APPLICATION NO.	FILING DATE	FIRST NAMED INVENTOR	ATTORNEY DOCKET NO.	CONFIRMATION NO.
10/775,724	02/10/2004	Masatoshi Yasutake	S004-5210	3824

Office Action Summary	Application No. 10/775,724	Applicant(s) YASUTAKE ET AL.	
	Examiner Quovaunda Jefferson	Art Unit 2823

FIG.7

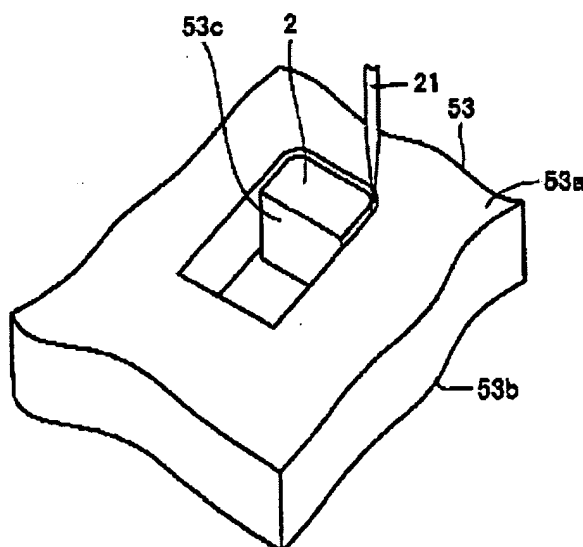
Regarding claim 3, Hirose teaches the method of preparing a sample chip and observing its wall surface of claim 2, wherein said first step includes processing the sample chip so that a stepped portion according surface to difference in material is formed in a surface to be observed with the scanning probe microscope (Figure 7).

Regarding claim 6, Hirose further teaches the method of preparing a sample chip and observing its wall surface of claim 5, wherein said first step includes processing the sample chip so that a stepped portion according to difference in material is formed in a face to be observed with the scanning probe microscope (Figure 7).

Regarding claim 12, Hirose further teaches the method of preparing a sample chip and observing its wall surface of claim 11, wherein said first step and/or fifth step include processing the sample chip so that a stepped portion according to difference in material is formed in a face to be observed with the scanning probe microscope (Figure 7).
